SUBJECT: EDWIN I. HATCH NUCLEAR PLANT, UNITS 1 AND 2 - REQUEST FOR
ADDITIONAL INFORMATION ASSOCIATED WITH NEAR-TERM TASK
FORCE RECOMMENDATION 2.1, SEISMIC HAZARD AND SCREENING
REPORT (TAC NOS. MF3772 AND MF3773)

REQUEST FOR ADDITIONAL INFORMATION
NEAR-TERM TASK FORCE RECOMMENDATION 2.1
SEISMIC HAZARD AND SCREENING REPORT
EDWIN I. HATCH NUCLEAR PLANT UNITS 1 AND 2
DOCKET NOS. 50-321 AND 50-366

Review of material parameters used in the site response analysis

Figure # 1

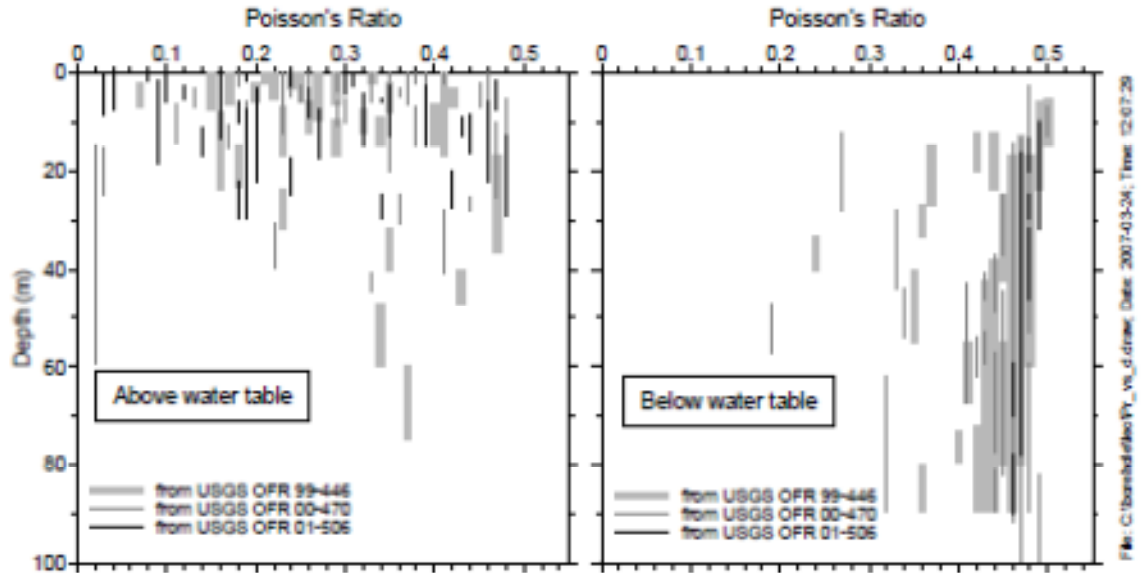
- a) From the Tampa geologic unit down to the Triassic (basement) a Poisson's ratio of 0.25 was used to estimate shear-wave velocity (V_s) values, which range from 3794 fps (feet/sec) to 6657 fps for these layers. As shown in Figure # 1 below, which is based on measurements described in Brown et al. (2002)³, a Poisson's ratio of about 0.4 would be more appropriate. Use of a Poisson's ratio of 0.4 would result in median base case V_s values ranging from 2683 fps to 4707 fps and 90th percentile V_s values ranging from 4195 fps to 7372 fps, assuming a logarithmic standard deviation of 0.35.

Based on the depth of the layers beneath the subsurface, provide the bases for use of a Poisson's ratio of 0.25.
